Product Change Notification / SYST-28ZNPW394

ERRATA - PIC18(L)F24/25K40 Family Silicon Errata and Data Sheet Clarification Revision

PIC18(L)F24/25K40 Family Silicon Errata and Data Sheet Clarification

Figure 1. 28-pin SPDIP, SSOP, SOIC

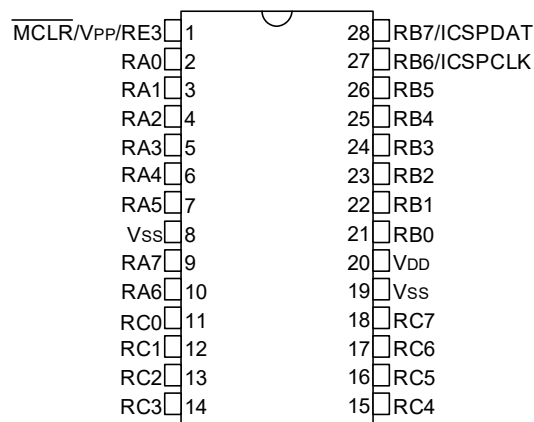
The correct marking for pin 26 on the 28-pin SPDIP/SSOP/SOIC package is **RB5**.

Figure 38-10: ADC Conversion Timing (ADC Clock F_{OSC}-Based)

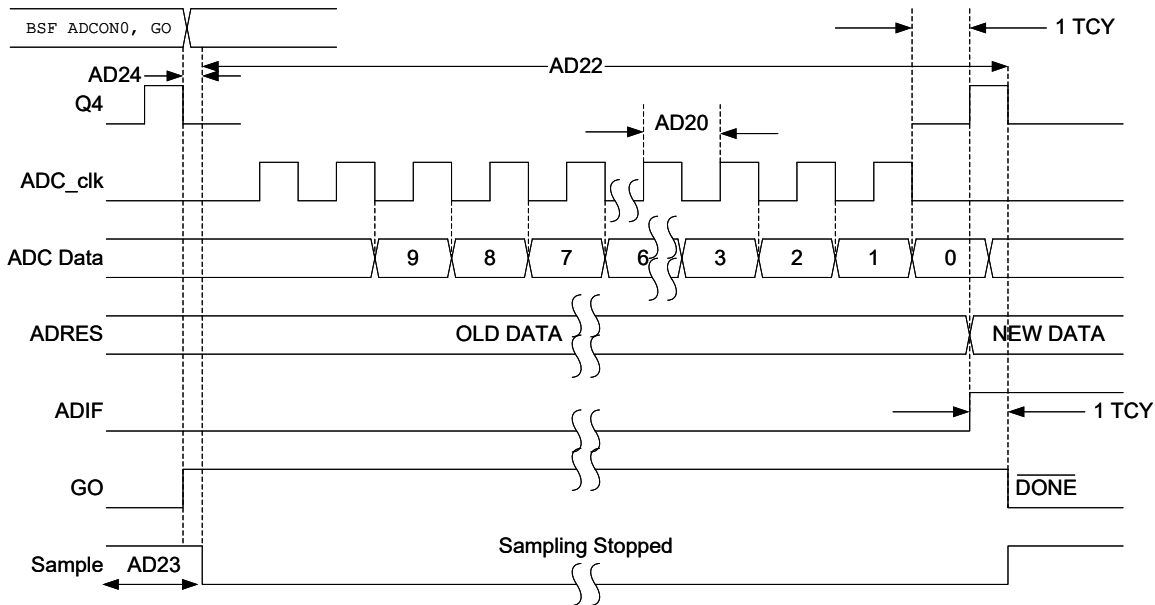
Refer to the images below for corrections of Figure 38-10 and Figure 38-11. Previously, the parameter numbers were incorrect.
